Our ref: 64120 – 05 A

Planning Ref: 251984

Site Land South of Bridge Farm, Reading Road, Arborfield, Wokingham, RG2 9HT

Our comments are provided below for the list of comments the Lead Local Flood Authority has made towards Pre commencement of reserved matters condition 3 (*in italic, bold*): PRP Responses in [Blue](#)

Title:
Drainage Plan
Sheet 1

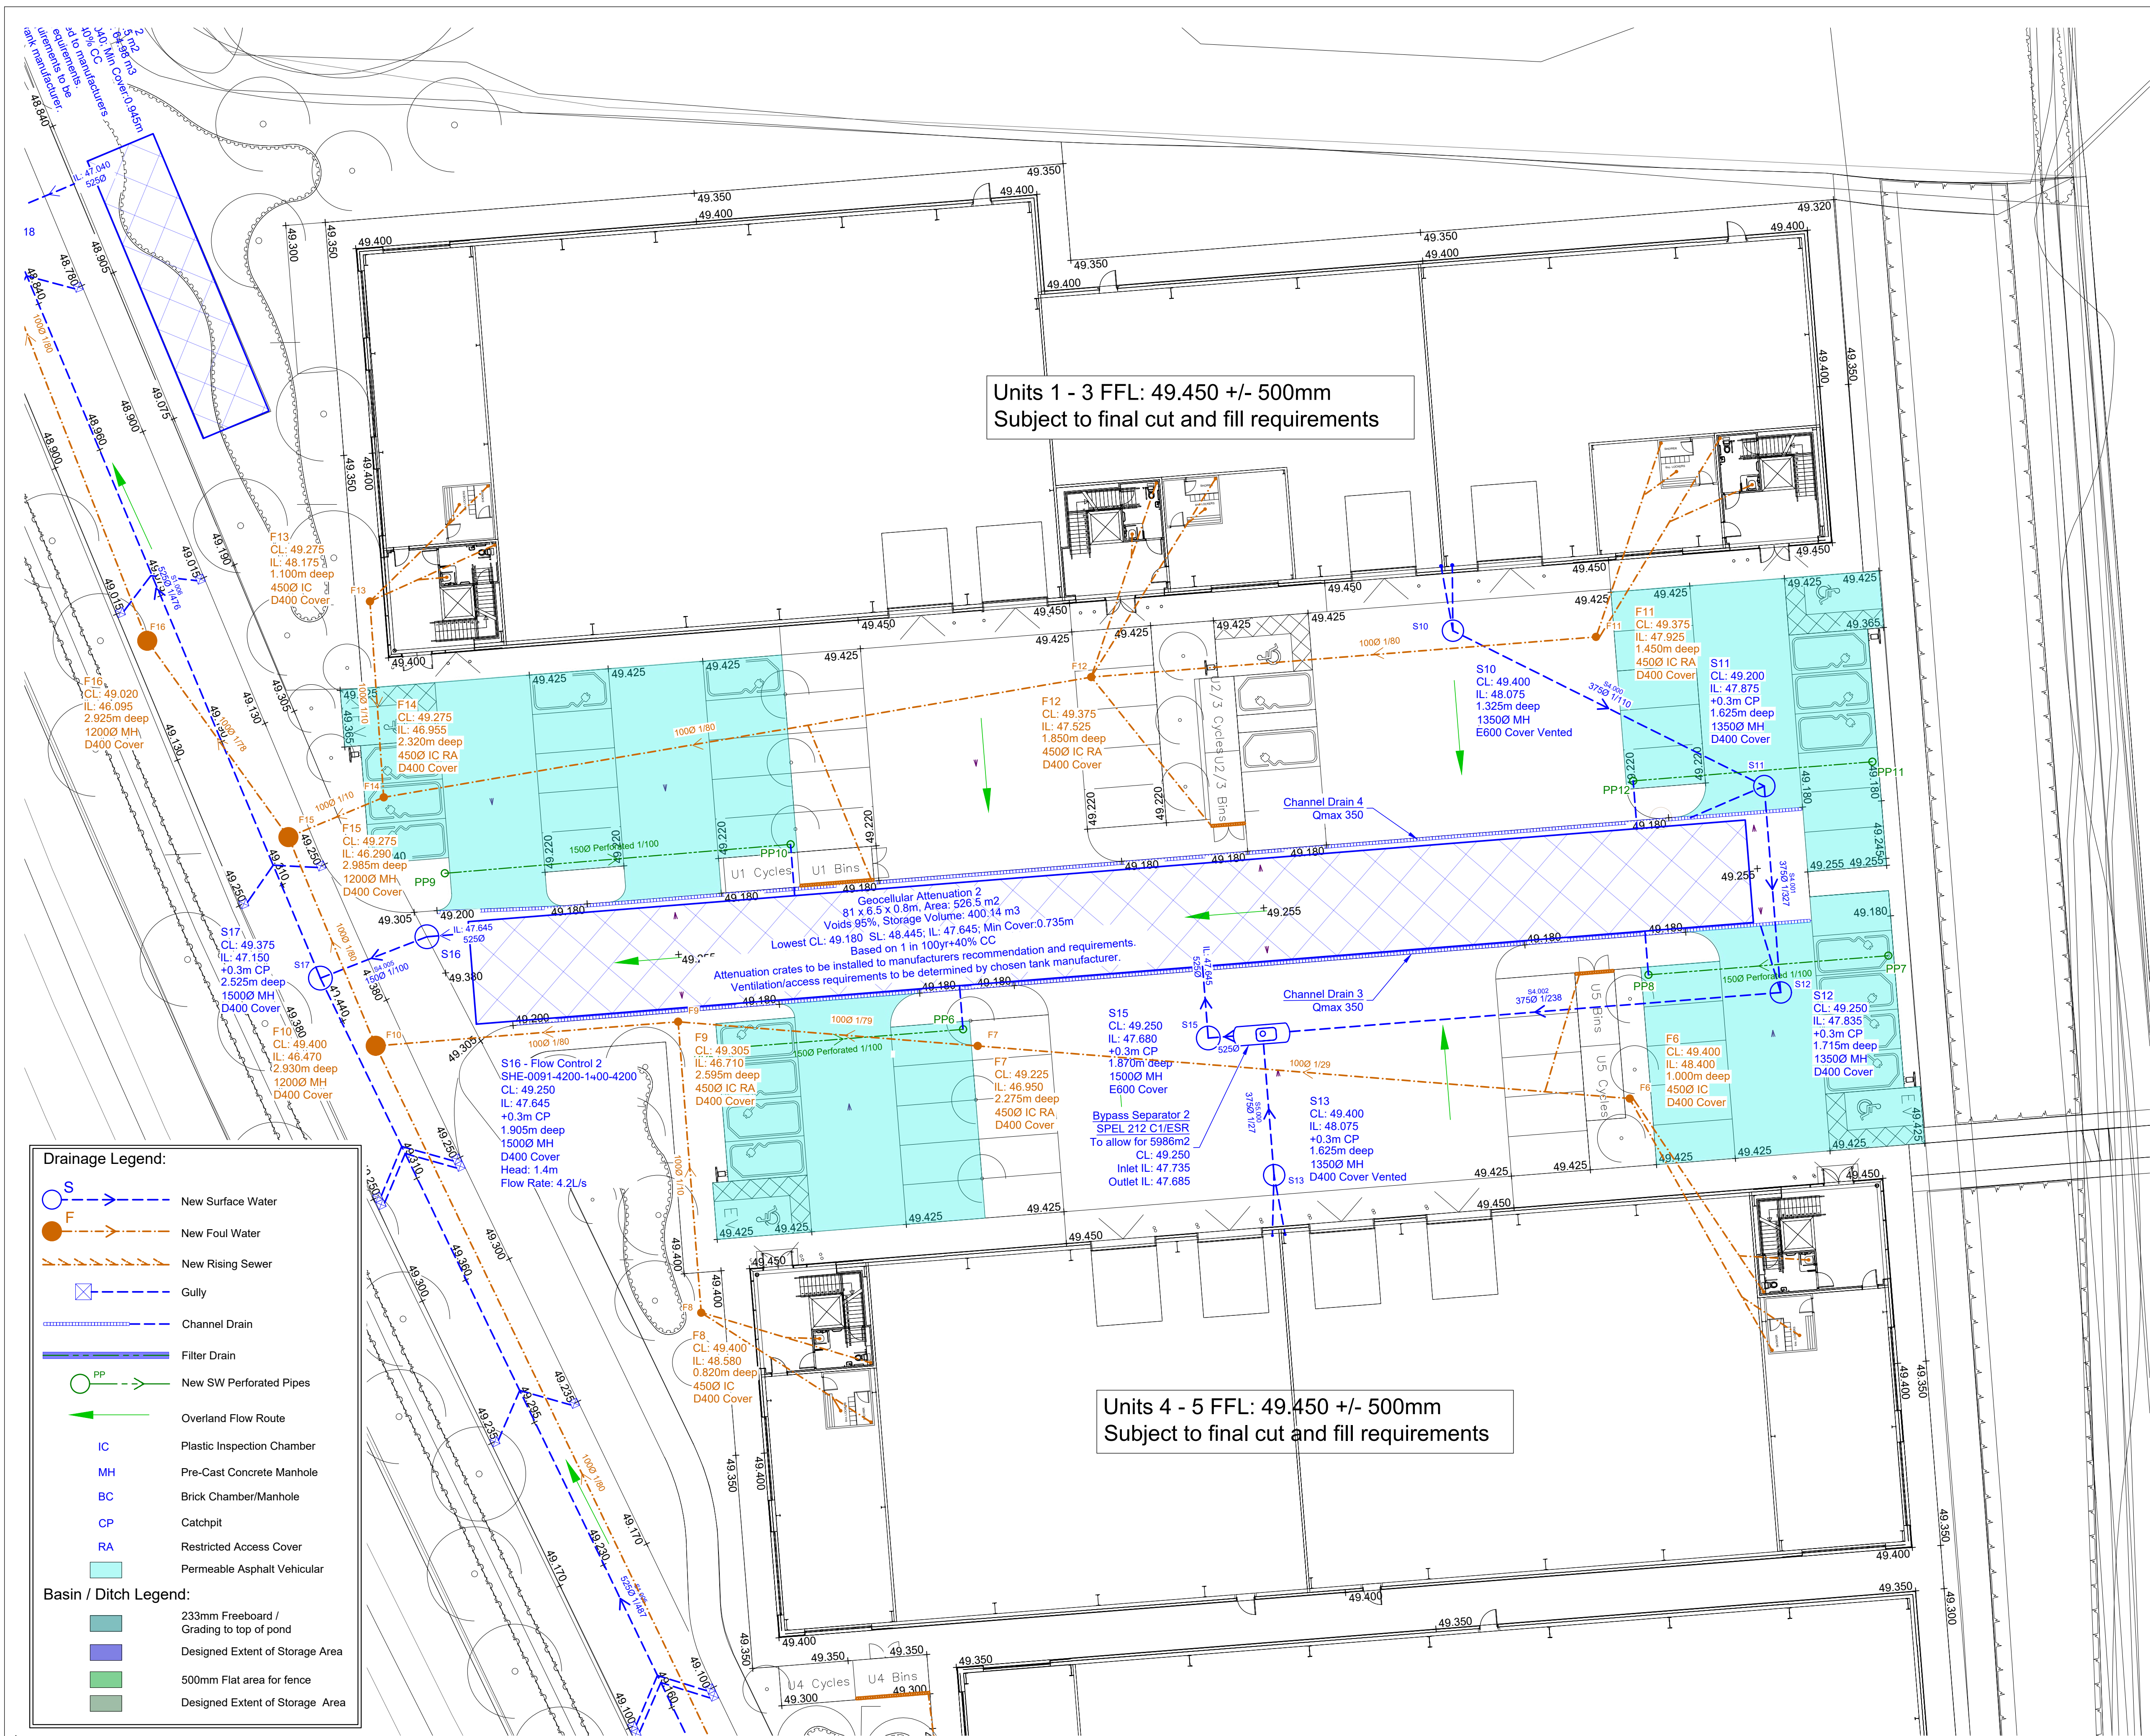
- a) Identify existing and proposed discharge points, including connection to the drainage ditch to the northwest or other approved watercourse/sewer;***
- b) Include runoff modelling (e.g., causeway flow, 1 in 100-year storm plus climate change) demonstrating that post-development surface water flows will not increase flood risk on or off site;***
- c) Provide details of attenuation measures (e.g., swales, ponds, storage tanks) compatible with the high soil saturation, ponding, and River Terrace Deposits identified;***
- d) Provide details of how the landscaping will integrate with the surface water drainage features.***
- e) Provide details of groundwater and excavation management.***

Surface water runoff from the main development area will be collected and conveyed to the north-west ditch via a flow-restricted, gravity-fed attenuated system. A total storage volume of approximately **916 m³** is provided through a combination of underground attenuation tanks and an attenuation basin. Discharge from the main site will be limited to **5.3 l/s**. All discharge points are shown and detailed on the accompanying drainage drawings.

- c) The proposed attenuation measures comprise reprofiled drainage ditches, an attenuation basin, and underground attenuation tanks, the details of which are provided on the enclosed drawings.
